**CCL 27/07/2021 – FREDERICK STREET, MEREWETHER
– PROPOSED RAISED PEDESTRIAN CROSSINGS**

ITEM-79 **Attachment A:** Plan – Raised Pedestrian Crossing – Frederick Street at Coane Street, Merewether

ITEM-79 **Attachment B:** Plan – Raised Pedestrian Crossing – Frederick
Street at Berner Street, Merewether

SUMMARY OF SUBMISSIONS – RAISED PEDESTRIAN CROSSING – FREDERICK STREET AT COANE STREET, MEREWETHER

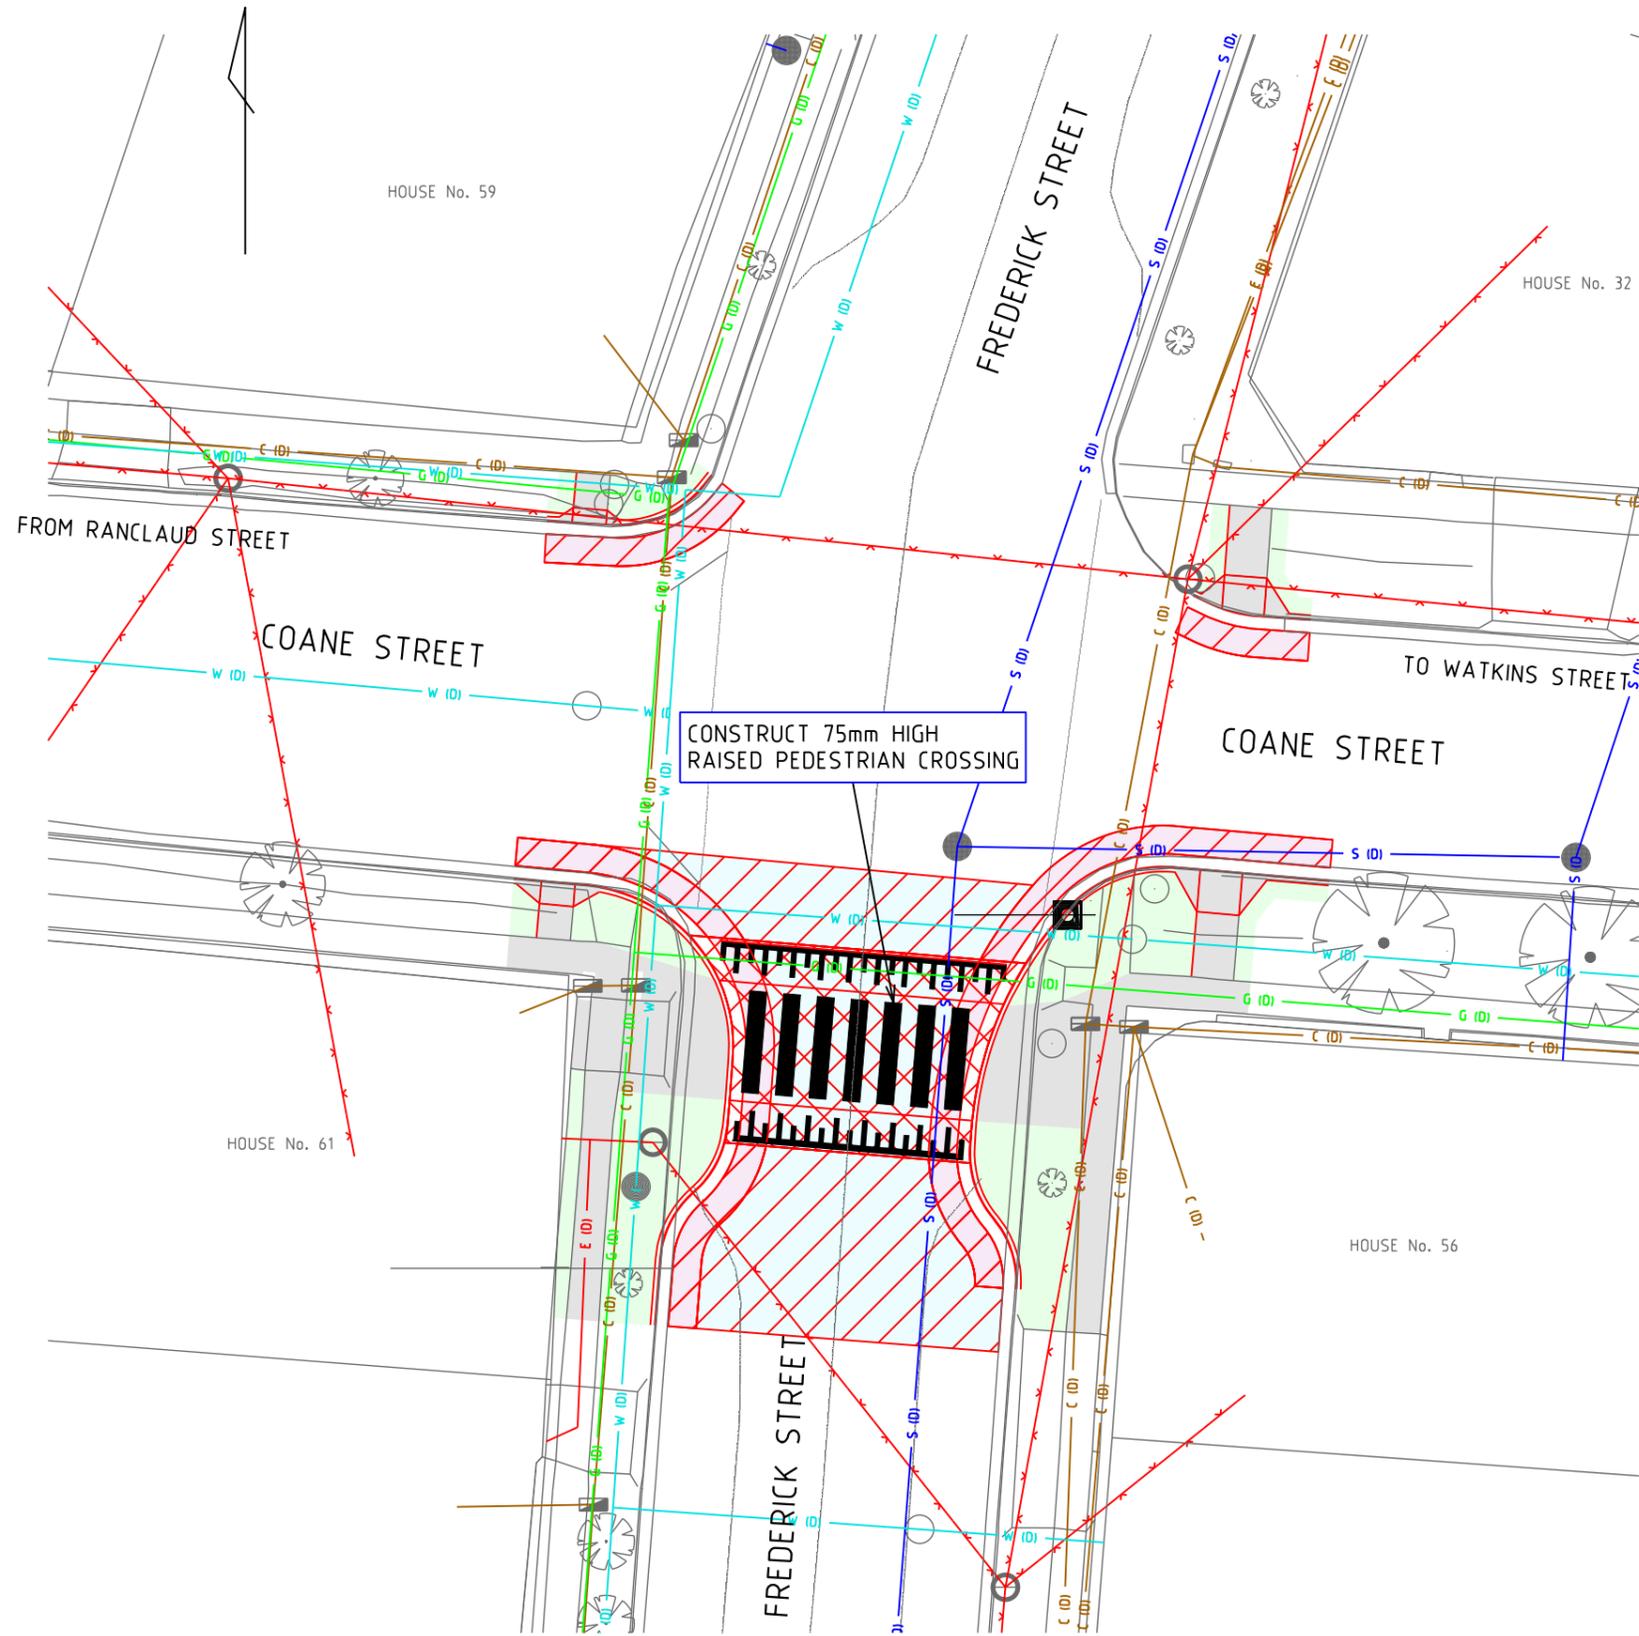
No.	Document Date	Reference	Project Support	Summary of Submission	CN Comment
1	16/04/2021	TR2021/01086	Yes, with changes	Respondent considers that a pedestrian crossing on Frederick Street is greatly needed but that it would be better located at the Berner Street intersection, as this is midway between the two refuges (John Parade and Helen Street) and where the majority of pedestrians from Merewether cross to access the beach and Bathers Way. Respondent notes that the constant flow of traffic along Frederick Street makes it very difficult to cross.	Noted. Provision of an additional crossing on Frederick Street at Berner Street has been supported by the Newcastle City Traffic Committee and is being investigated.
2	16/04/2021	TR2021/01074	Yes	Respondent strongly supports the proposal, noting issues with poor sight distances due to parked vehicles. Respondent also suggests implementation of a traffic calming device south of the intersection with Helen Street.	Noted. Provision of an additional (raised) crossing on Frederick Street at Berner Street is being investigated.

3	16/04/2021	TR2021/01075	Yes, with changes	Respondent supports a pedestrian crossing on Frederick Street but requests that it be located at Berner Street. Respondent notes that the Berner Street intersection is on a direct path from Dixon Park Beach and Dixon Park and that it is currently very dangerous to cross.	Provision of an additional crossing on Frederick Street at Berner Street is being investigated.
4	16/04/2021	TR2021/01705	Yes, with changes	Respondent supports the proposal but requests that a pedestrian crossing is also installed at Berner Street.	Noted and supported. Provision of an additional crossing on Frederick Street at Berner Street is being investigated.
5	16/04/2021 1	OT2021/01943	Yes	Respondent strongly supports the proposal, noting current conditions are unsafe with poor sightlines.	Noted.

No.	Document Date	Reference	Project Support	Summary of Submission	CN Comment
				8am and 10am, and on weekends. The respondent notes other locations in need of crossings, including Mitchell Street. In a subsequent submission, respondent notes that more people cross at Berner Street and that this location would be better for the community and not impact driveways.	
14	18/04/2021	OT2021/01929	Yes, with changes	Respondent supports a pedestrian crossing at the nominated location but requests that it not be raised. The respondent is concerned about noise impacts.	Concern noted. Raising of the crossing will assist in slowing traffic and improving safety.
15	18/04/2021	OT2021/01930	Yes	Respondent supports the proposal. Respondent requests that as part of the scope, a centre line be marked on Coane Street where it bends (at Ranclaud Street) as drivers cut the bend and there have been several near misses.	Noted. Linemarking on Coane Street near Ranclaud Street to be added to project scope.

39	22/04/2021	OT2021/02131	No	The respondent considers that the crossing should be located at the intersection with Berner Street, as it a flatter, more direct route to Mitchell Street.	Provision of an additional crossing on Frederick Street at Berner Street is being investigated.
40	22/04/2021	OT2021/02130	Yes	Respondent supports the proposal, noting current difficulties faced by pedestrians and cyclists in crossing. Respondent requests consideration of a similar concept for Morgan and Ridge streets.	Noted. CN has commenced a project for delineation of a principal pedestrian network, with consultation expected to be undertaken later in 2021. This will inform future work programs.
41	22/04/2021	OT2021/02083	Yes, with changes	Respondent supports the provision of a pedestrian crossing on Frederick Street, but considers that Berner Street would be a better location. Reasons given are that Berner Street	Provision of an additional crossing on Frederick Street at Berner Street is being investigated. Linemarking and parking changes will improve sightlines. Initial measures were proposed to

No.	Document Date	Reference	Project Support	Summary of Submission	CN Comment
61	25/04/2021	OT2021/02073	Yes, with changes	Respondent supports the proposal for the crossing at Coane Street and requests that a crossing be installed at Berner Street also, as most people cross at Berner Street.	Provision of an additional crossing on Frederick Street at Berner Street is being investigated.
62	25/04/2021	OT2021/02072	Yes	Proposal supported. No comments provided.	Noted.
63	25/04/2021	OT2021/02128	Yes	Proposal supported. No comments provided.	Noted.
64	25/04/2021	OT2021/02071	Yes, with changes	Respondent supports the proposal for a crossing and requests that road humps are instated on approaches, to encourage traffic to slow down.	The crossing will be raised, with signage on approaches.
65	25/04/2021	OT2021/02070	Yes, with changes	Respondent supports the proposal for a crossing at Coane Street and suggests that a pedestrian refuge at Berner Street in addition.	Multiple submissions have requested that a crossing be provided at Berner Street. This is to be investigated, and alternatives if it is not feasible. A pedestrian refuge was initially proposed for Frederick Street near Coane Street, but on further investigation, would not accommodate required turn movements.

73	26/04/2021	OT2021/02058	Yes	Proposal supported. No comments provided.	Noted.
74	26/04/2021	OT2021/01997	Yes, with changes	Respondent considers that island crossings at the intersections of Frederick Street with both Coane Street and Berner Street would be effective.	Noted. A pedestrian refuge was initially proposed for Frederick Street at Coane Street, however, there is inadequate room (to accommodate required turning movements).
75	26/04/2021	OT2021/02162	Yes	Respondent strongly supports the proposal and considers that it would greatly improve pedestrian safety at this intersection.	Noted.

No.	Document Date	Reference	Project Support	Summary of Submission	CN Comment
86	27/04/2021	OT2021/02112	Yes	Respondent strongly supports the proposal and considers it a brilliant idea as the intersection is extremely dangerous turning from Coane Street into Frederick Street and many people, the majority children, cross at this location every day.	Noted.
87	27/04/2021	OT2021/02167		Respondent states that southbound traffic exiting Helen Street does so at speed. Respondent provided a concept diagram to address issues, which included traffic calming devices (chicanes or humps) midblock between Berner and Coane streets and between Robert and Helen streets, and roundabouts at Coane Street and Robert Street, with the intent being to slow traffic and allow for safe crossing by pedestrians.	Noted. Provision of an additional raised crossing at Berner Street will assist in slowing traffic. Consideration will be given to requirement for additional traffic calming devices. A roundabout with pedestrian facilities could not be accommodated at Coane Street.

88	27/04/2021	OT2021/02172	Yes, with changes	Respondent suggests inclusion of overhead pedestrian crossing signs to ensure drivers concentrate on the road. Respondent also suggests a roundabout to slow traffic and a pedestrian crossing at the invert or right hand turn to surf club premises.	A roundabout has previously been proposed at the intersection of Frederick Street and John Parade but is subject to further investigation.
89	27/04/2021	OT2021/02170	Yes, with changes	Respondent supports provision of a crossing but considers that it should be positioned mid-block (between Berner and Coane streets or Coane Street and John Parade), rather than at the intersection. Respondent notes the prevalence of large cars and occurrences of parking too close to corners, which makes crossing very difficult. Respondent is concerned about sight lines and requests that if	Noted. Provision of an additional crossing on Frederick Street at Berner Street is being investigated. Sight lines will be confirmed in detailed design, and will be in accordance with Austroads guides. A road safety audit will also be undertaken on the detailed design.
